Technical Bulletin

Model: Finisher SR3110/SR3120 Date: 13-Jan-12 No.: RD637001a
--

Subject: Firmware Release Note: Finisher SR3110/SR3120			Prepared by	r: T.Hirakawa
From: 1st Tech Service Sect., MFP/Printer Tech Service Dept				
Classification:	☐ Troubleshooting	☐ Part information	ion 🔲 /	Action required
	☐ Mechanical	Electrical		Service manual revision
	☐ Paper path	☐ Transmit/rec	eive 🔲 I	Retrofit information
	☐ Product Safety	Other (Firmv	vare) 🖂 -	Tier 2

Subject: Parts information for Finisher SR3110			Prepared by: S.Hayami		
From: 1st Tech Service Sect., MFP/Printer Tech Service Dept					
Classification:	☐ Troubleshooting	□ Part informate □ Part informate	ion	Action required	
	☐ Mechanical	☐ Electrical		☐ Service manual revision	
	☐ Paper path	☐ Transmit/rec	eive	☐ Retrofit information	
	☐ Product Safety	Other (Firmv	vare)	☐ Tier 2

9.Staple Transfer Section 2 (D637)

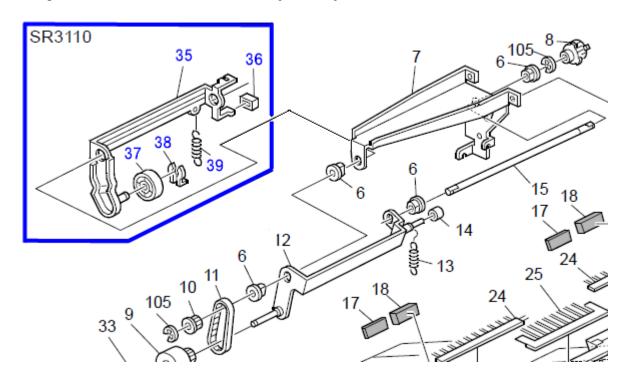
Old part number	New part number	Description	Q'ty	Int	Page	Index	Note
-	B7002631	ARM:PLATE:ASS'Y	1	-	18	35	For SR3110
-	B8042730	CUSHION:LINK:ARM	1	-	18	36	For SR3110
-	B8042625	ROLLER:MM28	1	-	18	37	For SR3110
-	54472681	SNAP RING	1	-	18	38	For SR3110
-	B7002635	TENSION SPRING:RELEASE:PLATE	1	-	18	39	For SR3110
